## AGENDA PUBLIC FACILITIES COMMITTEE Monday, December 16, 2013 2:00 p.m. Conference Room, Building 2 Beaufort Industrial Village 102 Industrial Village Road, Beaufort

SUBJ: **CHANGE ORDER # 4 FOR BLUFFTON PARKWAY PHASE 5A  
SEGMENT 2 CONSTRUCTION**

**RE: Bluffton Parkway 5A – Segment 2**  
**SC File #: 07.041794**  
**Beaufort County Project #: BEAU(001)**  
**F&ME Project No. C8300.00**  
**Subject: Bluffton Parkway 5A – Segment 2: LPA Change Order 004 – Drill Shaft Extensions**  
**(Executive Summary)**

RE: **Draft Addendum to the Geotechnical Report**  
Bluffton Parkway Phase 5A Segment 2

**SHAFT EXTENSION DETAIL - 84" DIAMETER SHAFTS**  
NOT TO SCALE

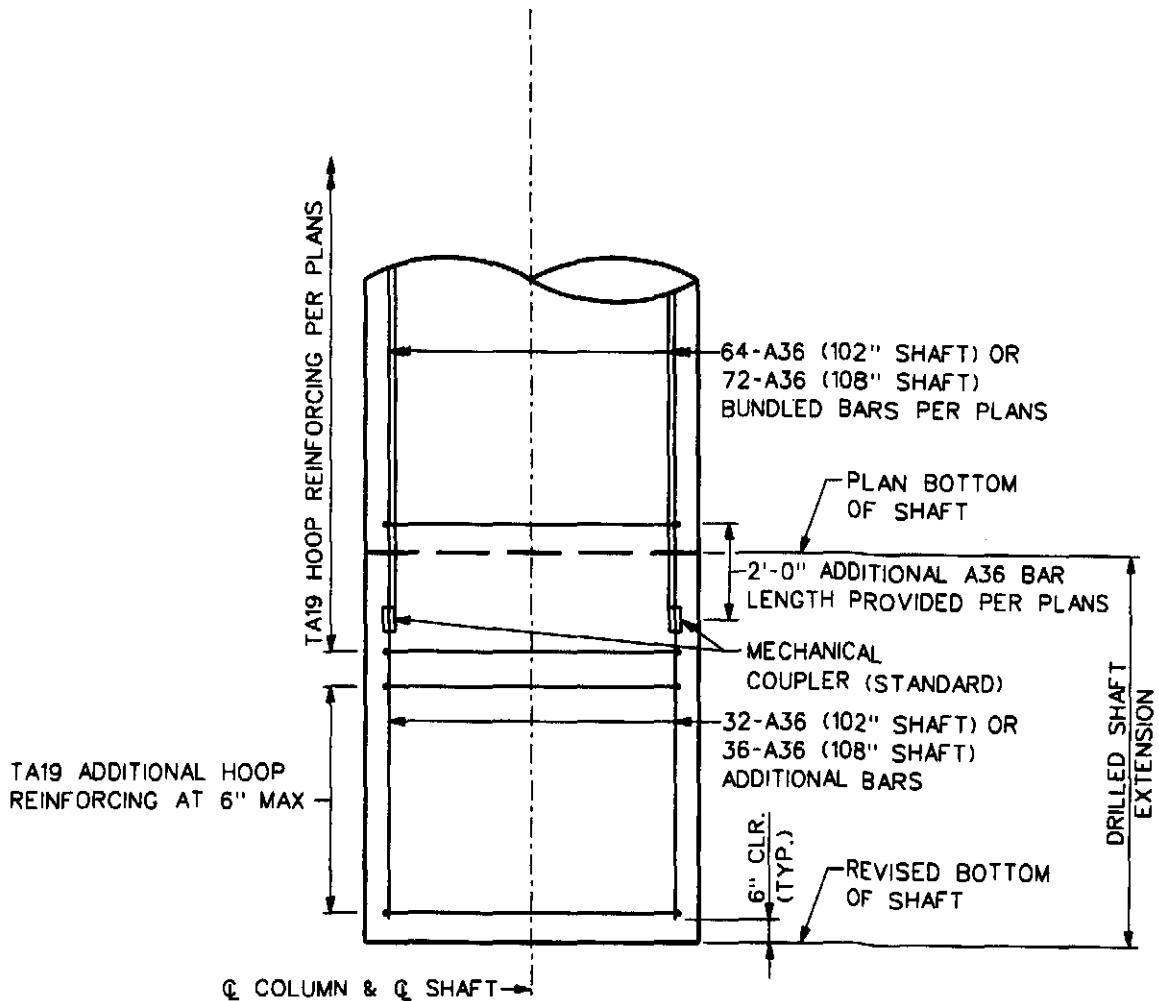
Following the LoadTest performed on the test shaft on 7/25/13, the results yielded unforeseen end bearing movements. With the test data, the Engineer of Record (ICA Engineering) recommended that certain drill shafts be extended to counter the end bearing movement. Attached is a summary of drill shaft extension lengths.

ICA Engineering presents this addendum letter to our original geotechnical report which was dated February 8, 2010 to reflect the changes in the drilled shaft lengths based on the results of the load test performed on a test shaft. We have reviewed the *Report on Drilled Shaft Load Testing (Osterberg Method)* prepared by LOADTEST and dated July 30, 2013 and subsequent correspondence from LOADTEST dated August 8, 2013. After review of this information, we feel that the measured skin friction values are reliable; however, we feel that the results of the test relating to end bearing are inconclusive. These two referenced reports provided by LOADTEST are included in Appendix II.

In most cases, the average length of the drilled shafts from Methods 1 and 2 above was then compared to the lengths currently shown in the plans and in cases where this average length is greater than the plan lengths, we are recommending lengthening the drilled shafts. Due to the inconclusive nature associated with the unit end bearing reported from LOADTEST (original report and updated analysis), we choose to use the average in most situations. The average was used since Method 1 involved the irregular "blending" of two resistance factors and Method 2 was based on assumptions that were made in order to account for irregular measurements taken from the load test. A couple of exceptions are mentioned in the calculations in Appendix I for the shafts at WB-2, WB-3, WB-9, WB-10 and WB-11, where the average was not used and the additional lengths were based solely on Method 1 due to excessive service capacity

**SHAFT EXTENSION DETAIL - 102" OR 108" DIAMETER SHAFTS**  
NOT TO SCALE
